DART AEROSPACE LTD	Work Order:	89621
Description: Crosstube Assembly (206L High Fwd)	Part Number:	D206-667-143
Inspection Dwg: D206-667-143 Rev: C		Page 1 of 2

DESIGN	97	DART AEROSPACE LTD	
DRAWN	RF	HAWKESBURY, ONTARIO, CANADA	
CHECKED	JP	DRAWING NO.	REV. C
MFG. APPR.	JP	D206-667-143	SHEET 2 OF 4
APPROVED	JP	TITLE	SCALE
DE APPR.	JP	CROSSTUBE ASS'Y (206L HIGH FWD)	NTS
DATE	08.11.06	COPYRIGHT © 2000 BY DART AEROSPACE LTD	
		THIS DOCUMENT IS PRIVATE AND CONFIDENTIAL AND IS SUPPLIED ON THE EXPRESS CONDITION THAT IT IS NOT TO BE USED FOR ANY PURPOSE OR COMMUNICATED TO ANY OTHER PERSON WITHOUT WRITTEN PERMISSION FROM DART AEROSPACE LTD.

DRAWING NO. D206-667-143	TITLE CROSSTUBE ASS'Y (206L HIGH FWD)	REV. C	DART AEROSPACE LTD ENGINEERING ORDER		D.E.O. NO. D206-667-143-C-1	SHEET NO. SHEET 1 OF 1	SCALE NTS
DRAWN <i>9P</i>	CHECKED <i>ASS</i>	MFG. APPR. <i>128</i>	APPROVED <i>MD</i>		DE APPR. <i>MD</i>		
DATE 11.07.15	DATE 11.07.20	DATE 11.07.21	DATE 11/07/21		DATE 11.07.21

DRAWING NO. D206-667-143	TITLE CROSSTUBE ASS'Y (206L HIGH FWD)	REV. C	DART AEROSPACE LTD ENGINEERING ORDER		D.E.O. NO. D206-667-143-C-2	SHEET NO. SHEET 1 OF 1	SCALE NTS
DRAWN AJS	CHECKED	MFG. APPR. <i>E</i>	APPROVED <i>A

DETAIL P
BONDING STRAP INSTALLATION 2 PL

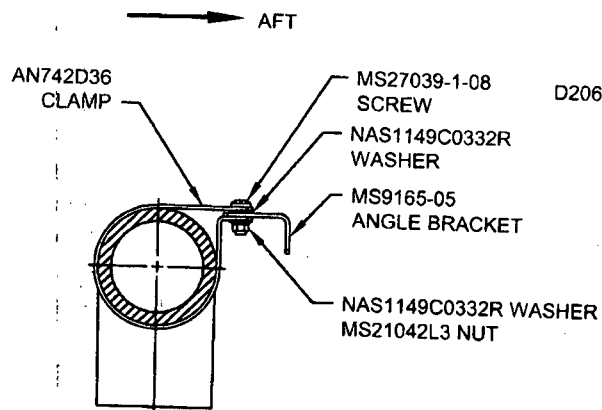
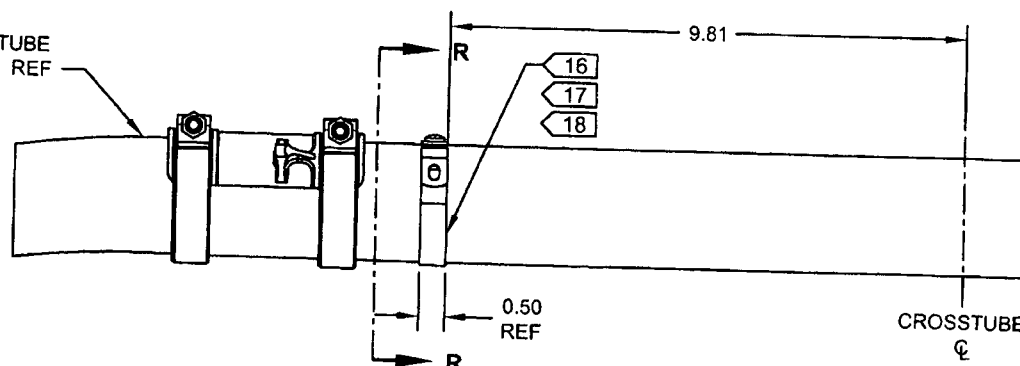
ADD ELECTRICAL GROUNDING STRAP

ITEM	QTY -143	PART NUMBER	DESCRIPTION
1	X	D206-667-143	CROSSTUBE ASSEMBLY (206L HIGH FWD)
10	2	AN742D36	CLAMP
11	2	MS9165-05	ANGLE BRACKET
12	2	MS21042L3	NUT (OR MS21042-3)
13	2	MS27039-1-08	SCREW
14	4	NAS1149C0332R	WASHER (OR AN960C10L)

- 16) MASK AREA UNDER CLAMP PRIOR TO PAINTING
- 17) SEAL EDGES WHERE AN742D36 CLAMP MEETS WITH THE CROSSTUBE USING SIKAFLEX-241/-291 OR MIL-S-8802 CLASS B2 OR PROSEAL 890 SEALANT
- 18) PERFORM RESISTANCE CHECK TO ENSURE MAX RESISTANCE IS 10 MILLIOHMS
